TO: All U.S. Ford and Lincoln Dealers
SUBJECT: **NEW VEHICLE DEMONSTRATION / DELIVERY HOLD**
Safety Recall 24S15 - **Supplement #2**
Certain 2023-2024 Model Year Bronco 5-door
Rear Door Child Safety Lock Inspection
REF: **NEW VEHICLE DEMONSTRATION / DELIVERY HOLD**
Safety Recall 24S15 - **Supplement #1**
Dated April 16, 2024

CERTAIN 2024 MODEL YEAR BRONCO 5-DOOR VEHICLES — REAR DOOR CHILD SAFETY LOCK INSPECTION

FIGURE 1

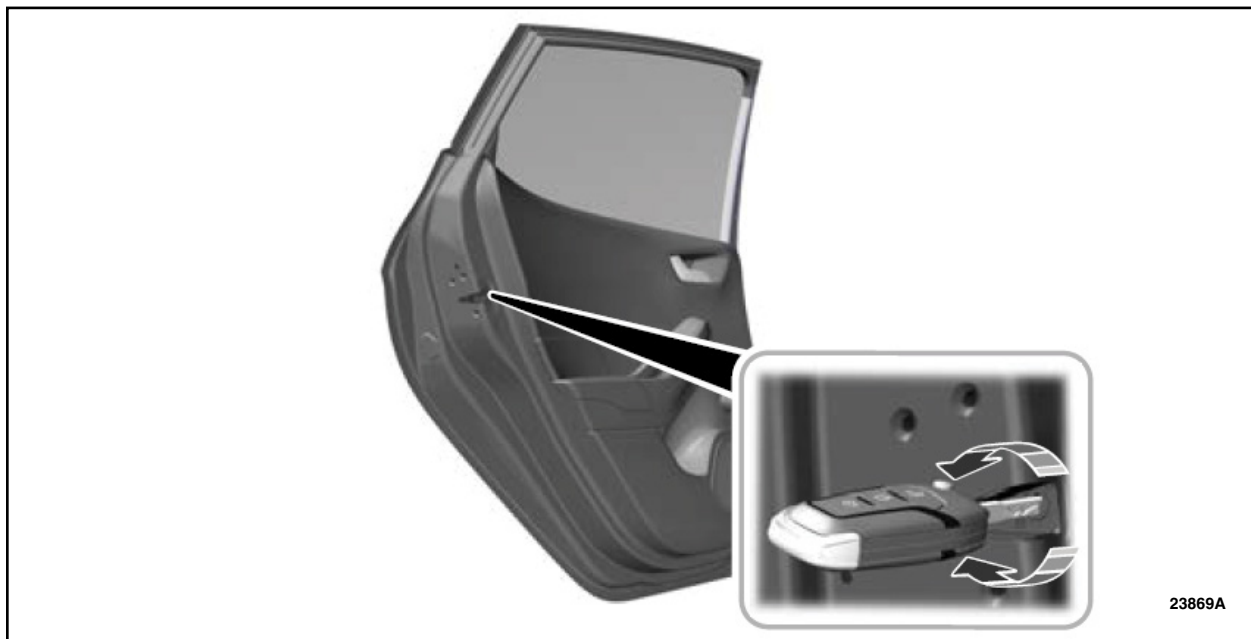
1. With the door open, engage the child lock on both rear left-hand (LH) and rear right-hand (RH) doors. See Figure 1.

NOTE: For the LH side turn key clockwise to engage. For the RH side turn key counterclockwise to engage.

FIGURE 2

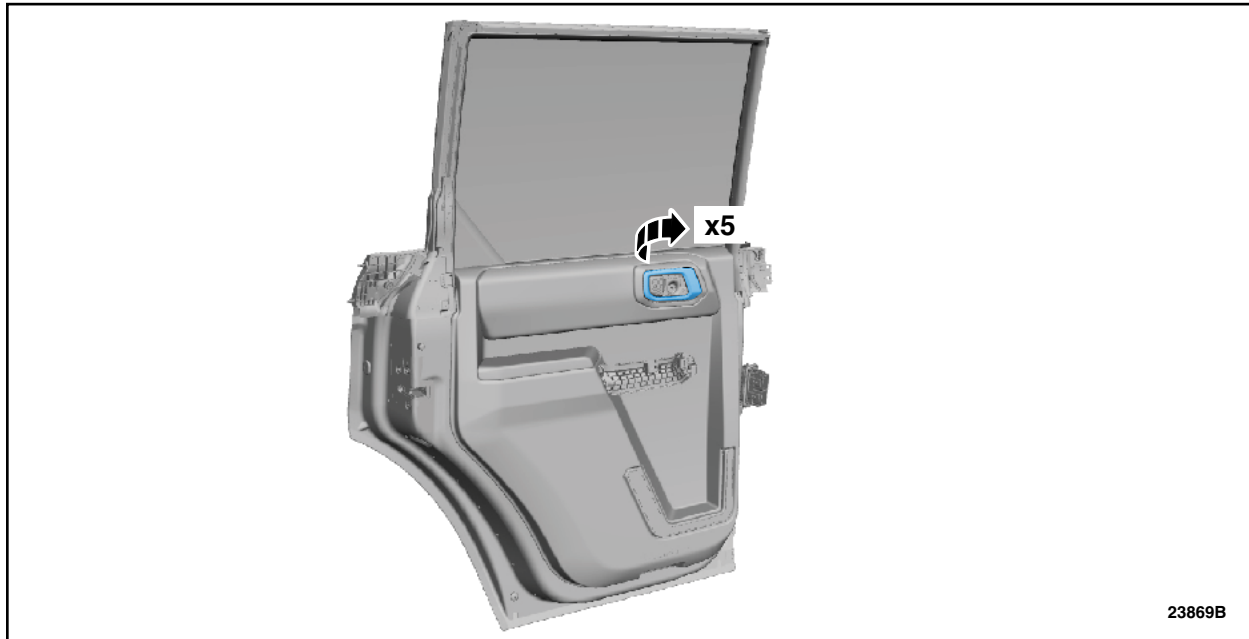
4. While sitting in the rear seat of the vehicle, pull the interior door handle fully, 5 times in succession. See Figure 2. Repeat with the opposite door handle. Did either door open during this procedure?

Yes - Continue to Step 5.

No - Exit the vehicle using the exterior door handle, roll-up the window, and disengage the child lock. Recall complete.
